**MR2011105-MDP-4 Pedestrian Walkway and Bridge, and the Preliminary submission of the ICC-B Site Development Plan**

**Staff Report Date: 01-29-15**

The Planning Board is being asked to provide advisory comments on the Pedestrian Bridge and Walkway; and the Preliminary Master Site Development Submission for the ICC -B campus. Staff is recommending the Board support the plan and transmit the recommendations to the Defense Intelligence Agency for their consideration.

Campus Drainage Areas

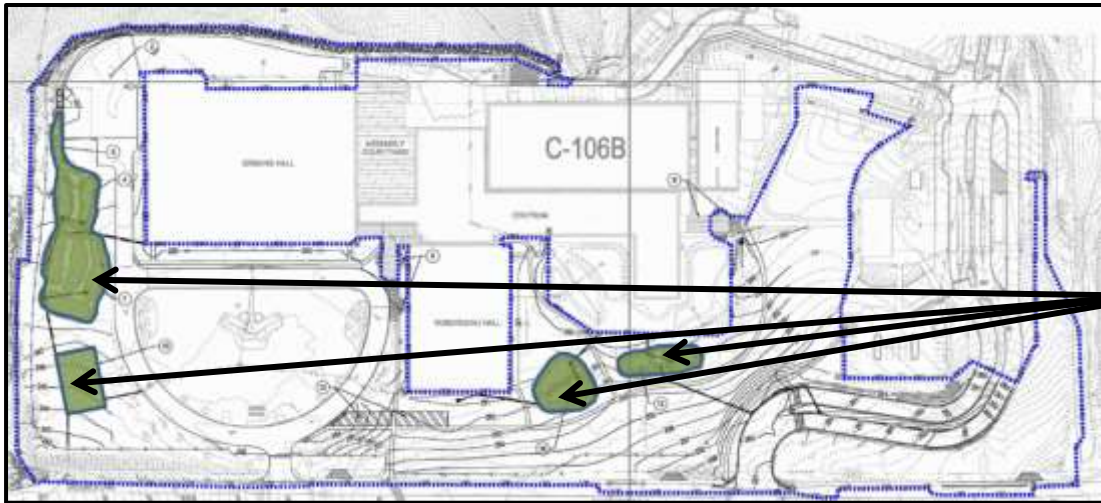
- Staff recommends supporting future recommendations by the National Capital Planning Commission regarding the proposed discharge of stormwater overflow from Area 3 that exceeds the 25-year storm event onto National Park property.
